Re: Port Ewen Fire District

Port Ewen Firehouse Construction Project

Addendum #3

SHEET: C-503

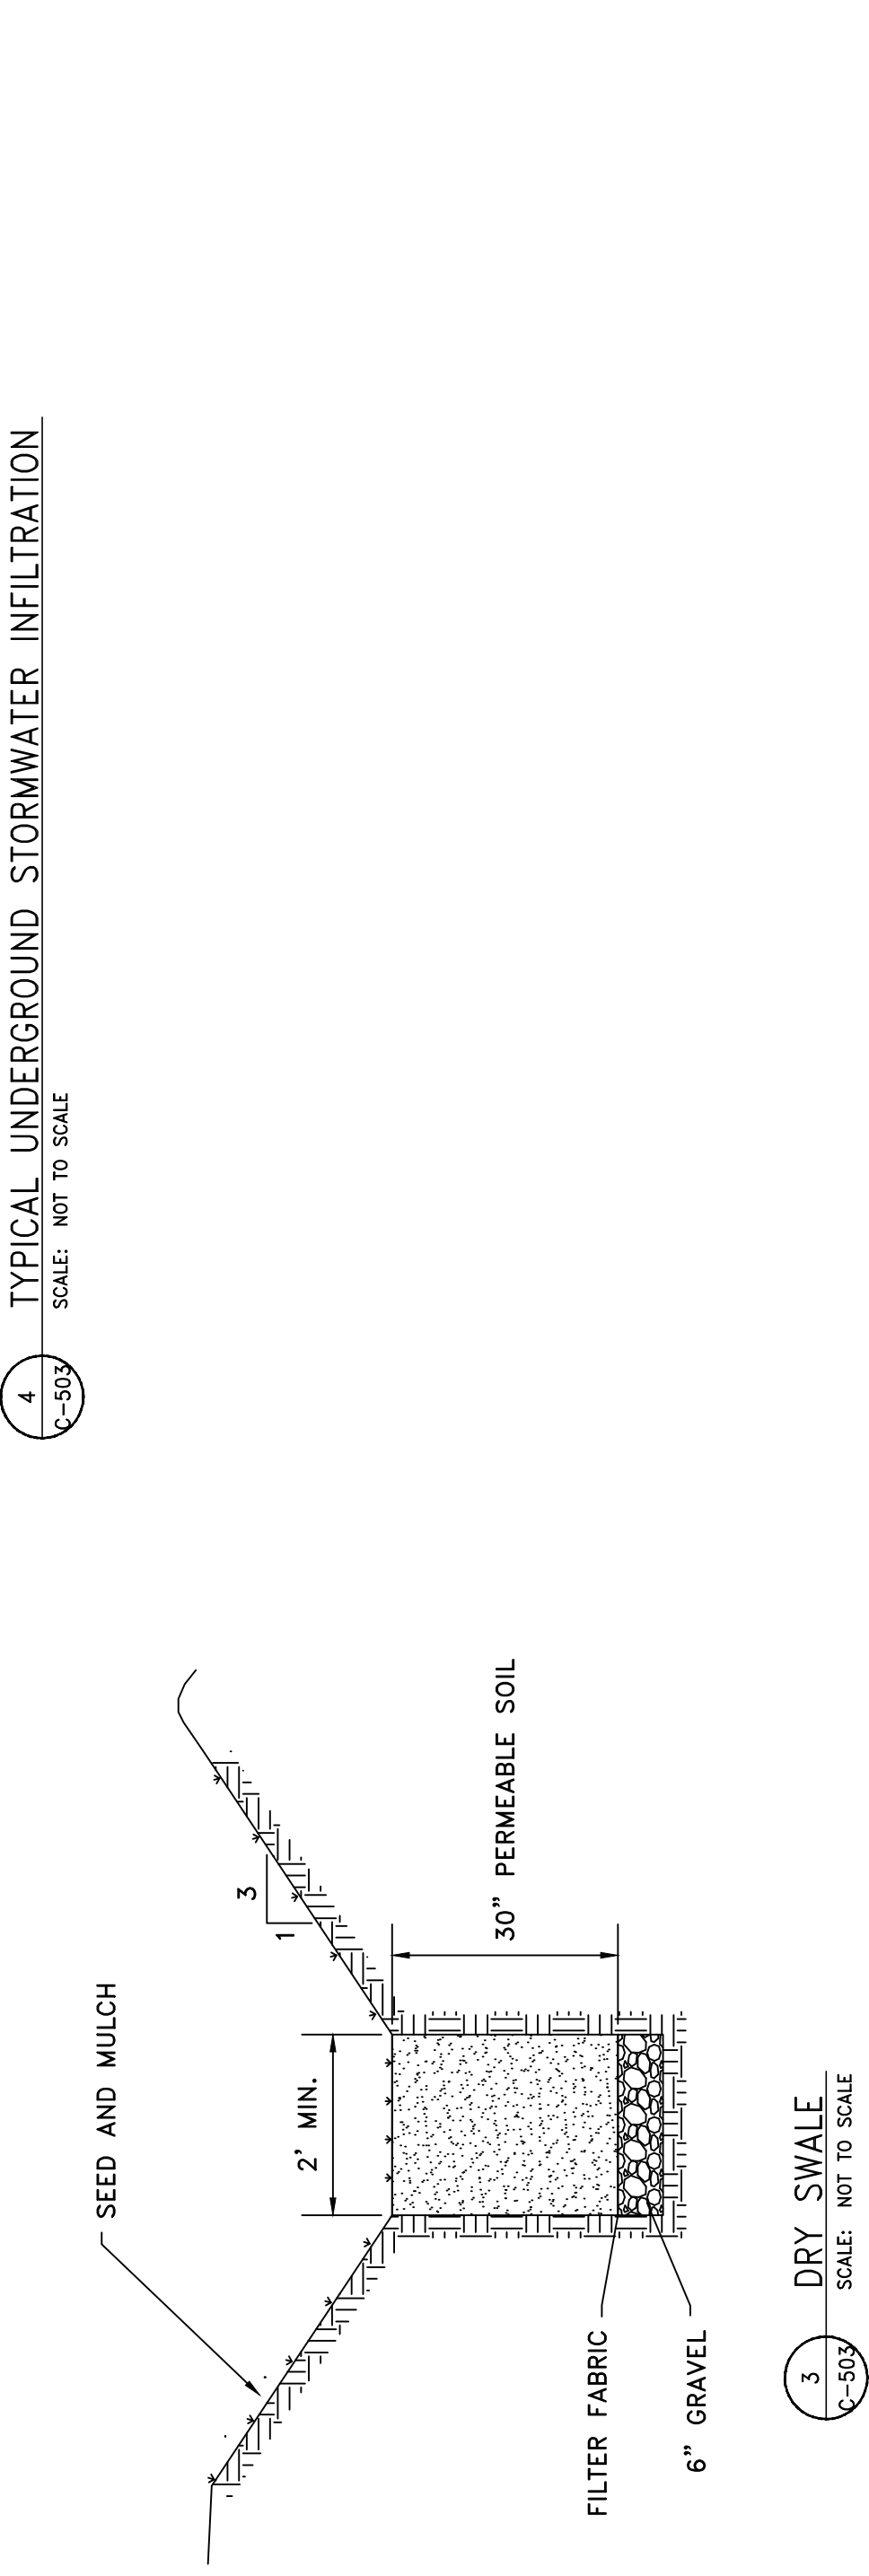
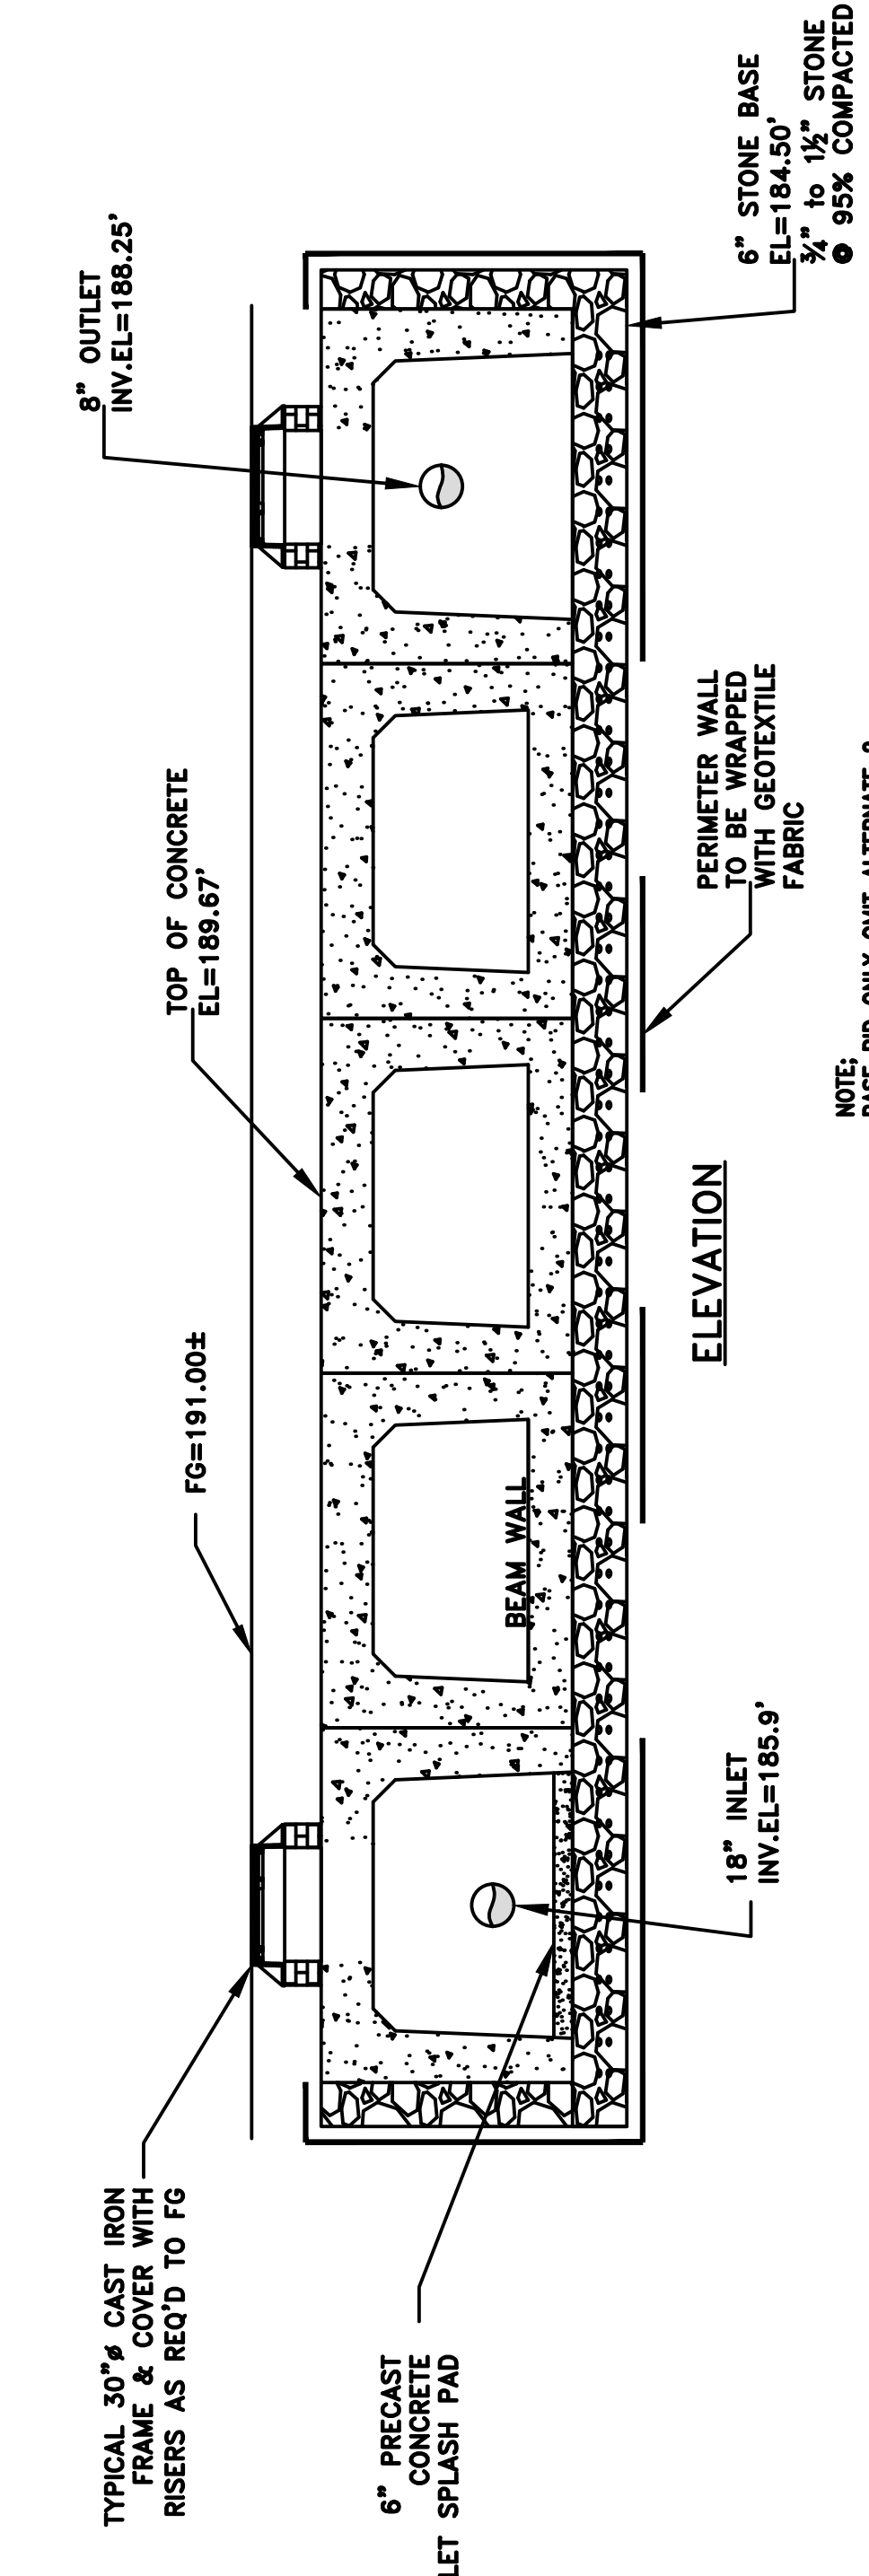
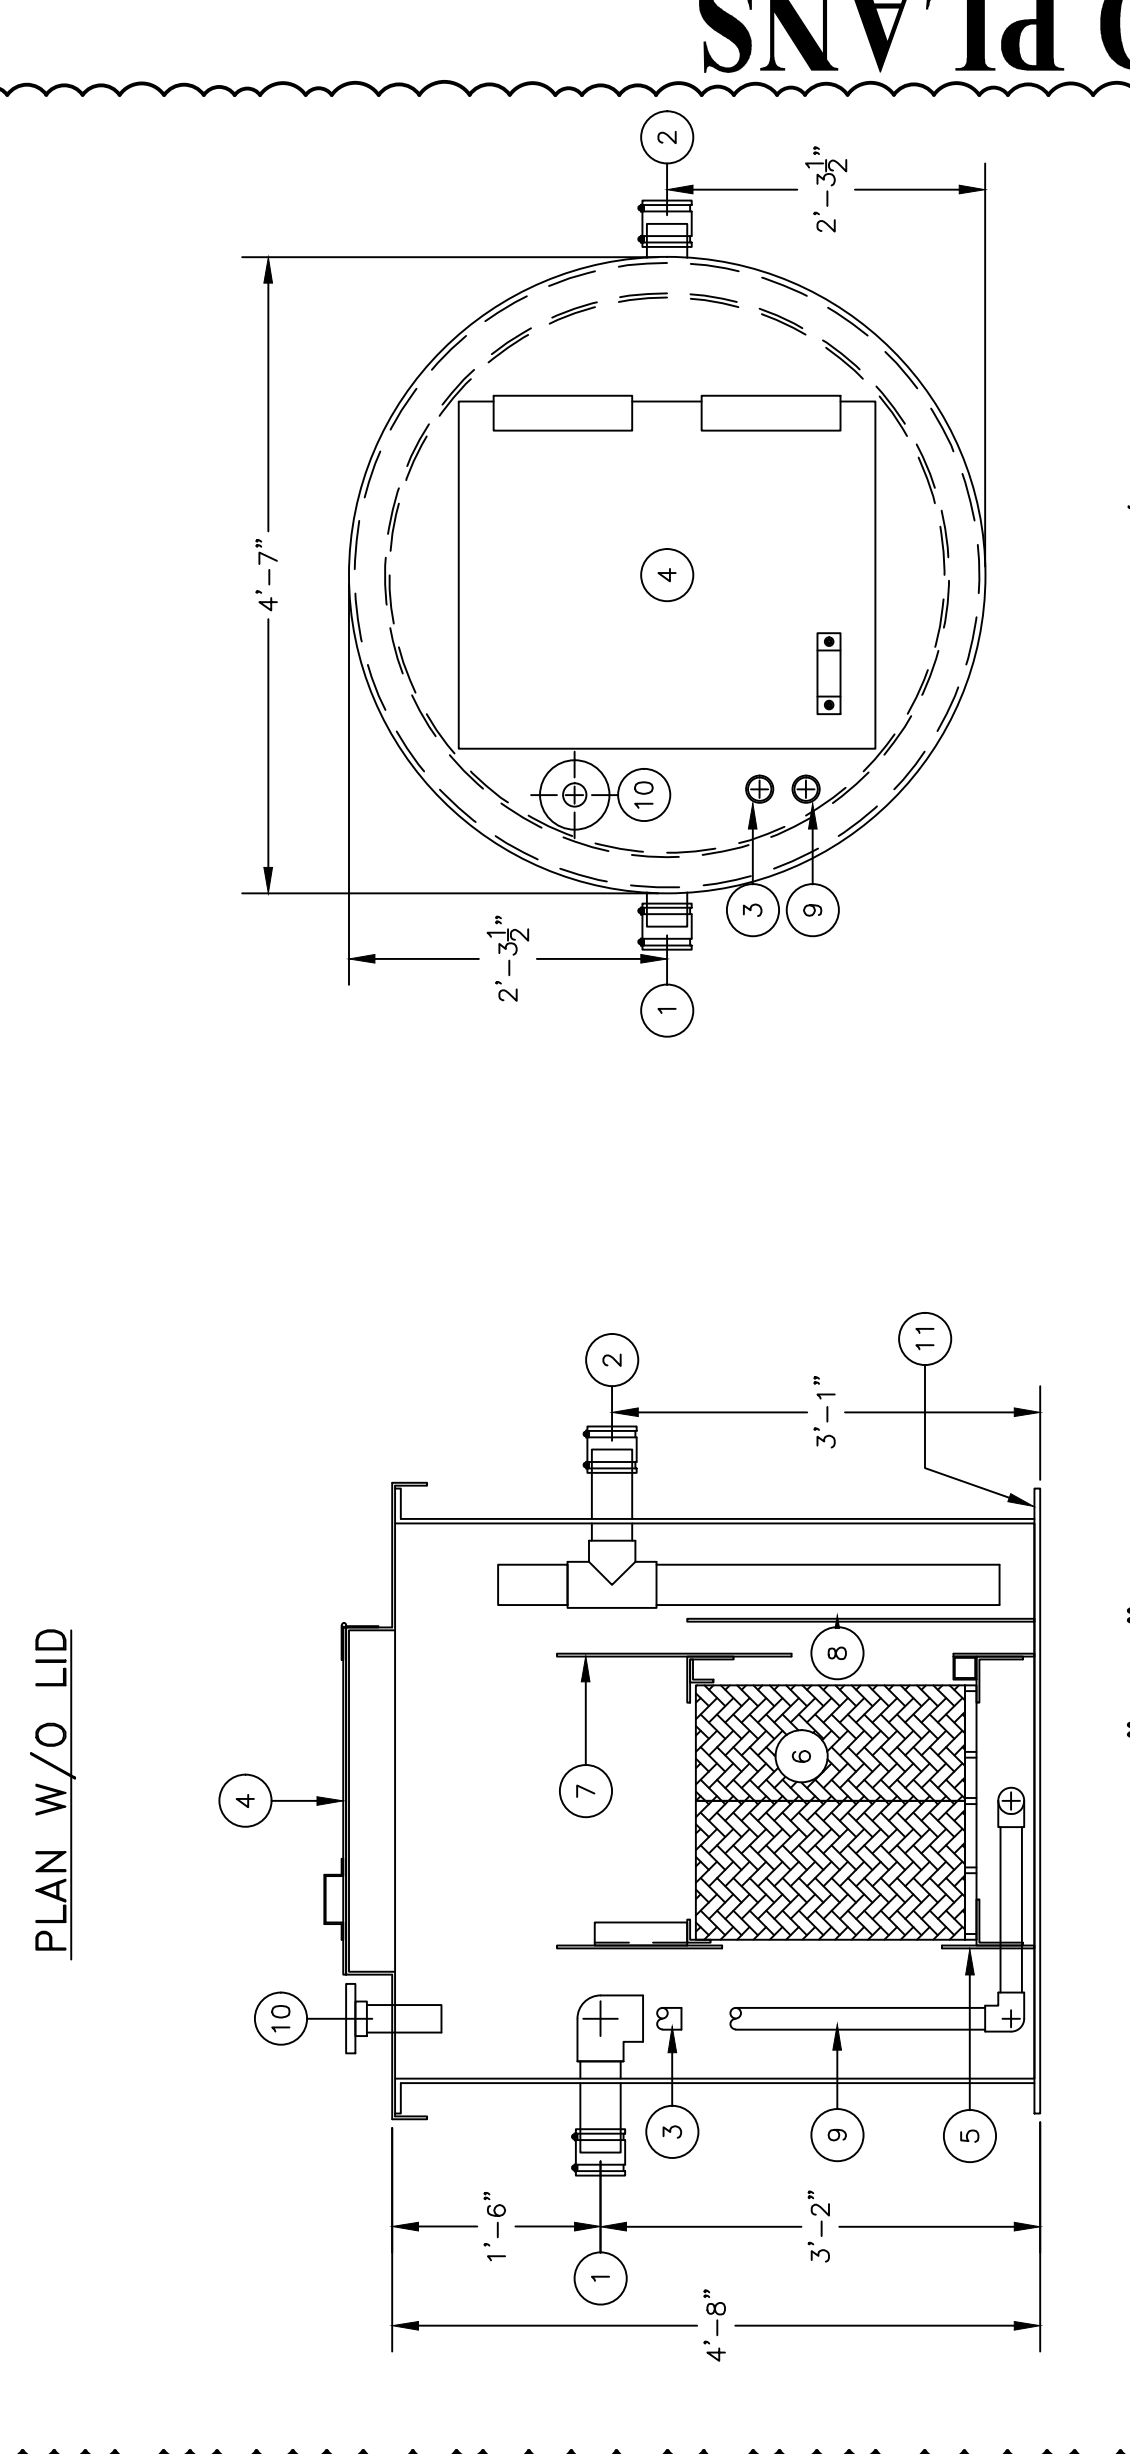
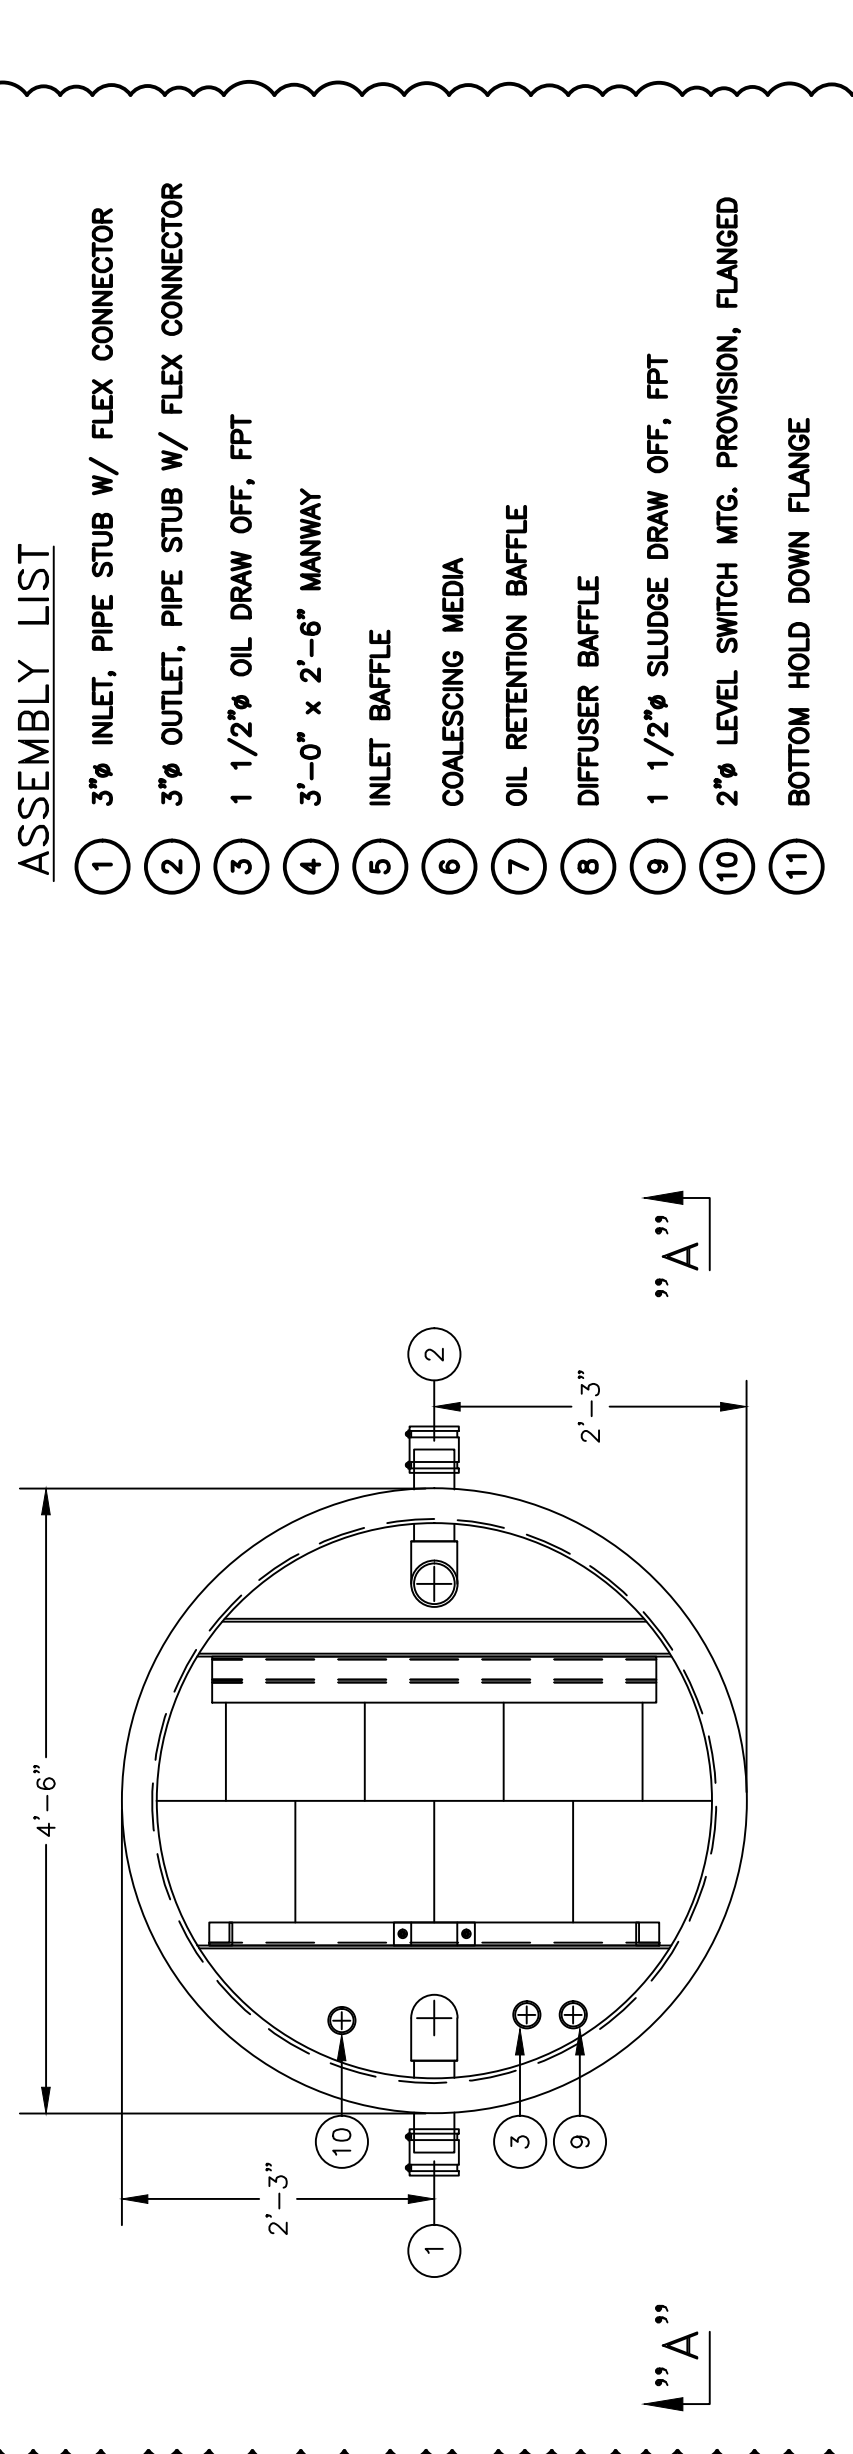
- Oil/Water Separator see detail sheet C-503.
- See revised sheet attached.
